REMARKS

Attorneys for Intel Corporation

FIG 1

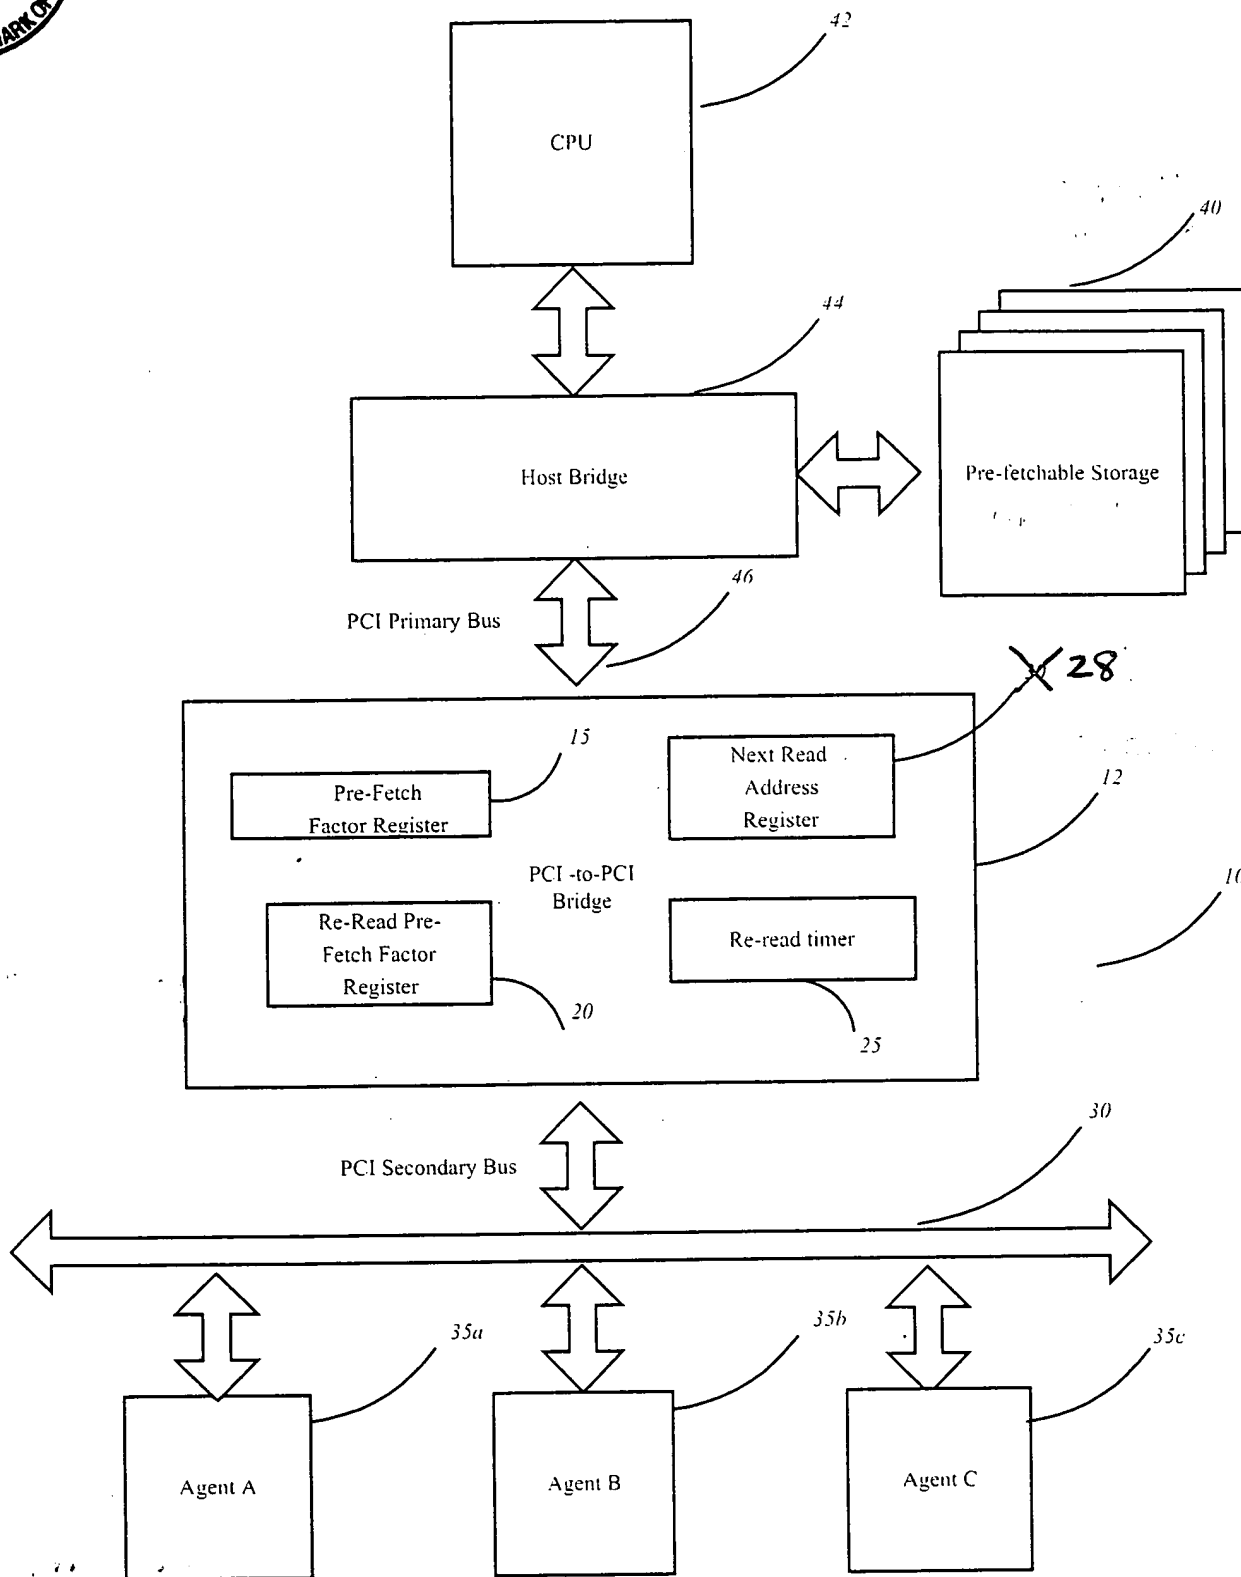
The Office Action objected to Fig. 1 because reference number "30" was used twice. Applicant has amended Fig. 1 and the specification to change the reference number "30" for the "Next Read Address Register" to "28."
